From: [Joshua de block](#)
To: [*CI-StPaul>Contact-Council](#)
Subject: Bike Plan
Date: Tuesday, April 23, 2024 9:03:25 AM

From: [Tim M](#)
To: [*CI-StPaul>Contact-Council](#); [#CI-StPaul_Ward7](#); [#CI-StPaul_Ward6](#)
Subject: St Paul Bike Plan Comments from Ward 7 Resident
Date: Tuesday, April 23, 2024 11:05:35 AM
Attachments: [image.png](#)

I am a resident of Dayton's Bluff and these are the comments I have on the St Paul Bike Plan. Overall it's a good plan, but there's a lot of missing pieces on the East Side.

Here's an image of the routes that I've mentioned.

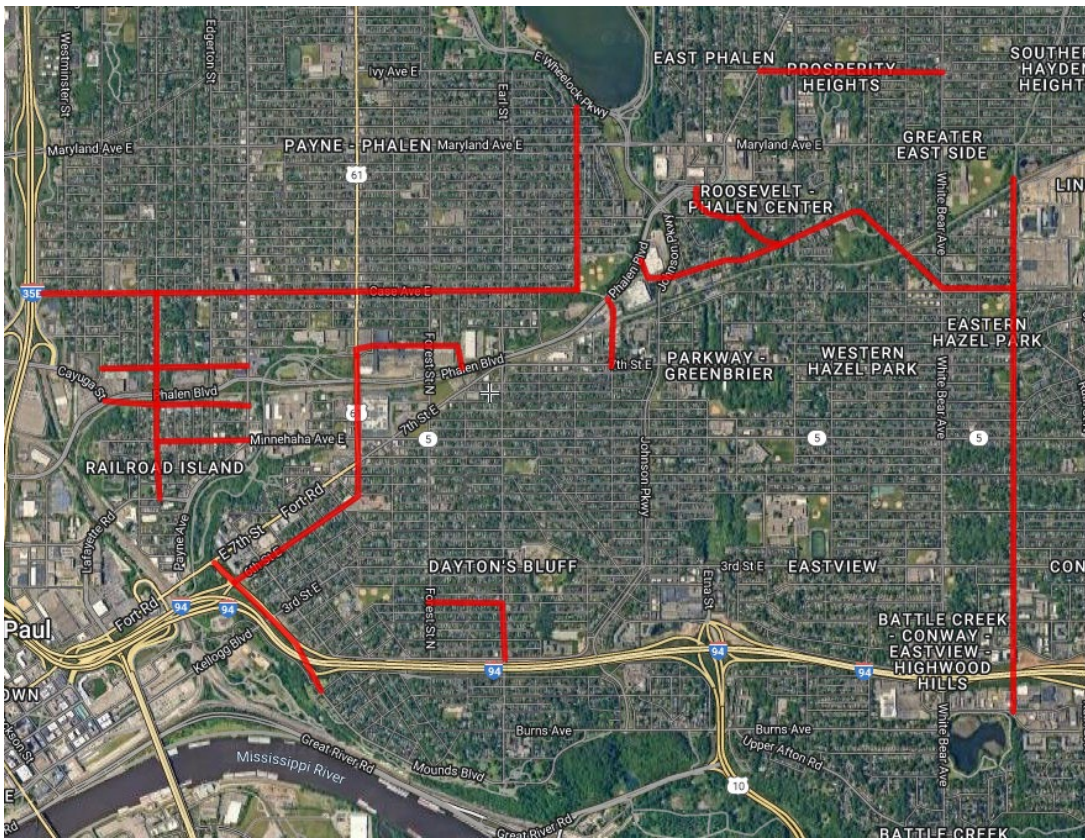
Railroad Island - There's a reason why this neighborhood has its name. By being fenced in on all sides by railroads, it requires bikers to go out of their way to go north or west of the neighborhood. The Cayuga Street station area plan had identified a reconnection of the former bridge over Phalen of Burr Street, and a connection from Bush Ave to Cayuga, not only creating a good connection for the future Purple Line but also to the Gateway Trail.

Other routes identified include: Case Ave, Whitall St, Wells St including an alleyway connection to Seeger Square Minnehaha Ave west of Edgerton, Duluth St north of Phalen and Atlantic south of Phalen
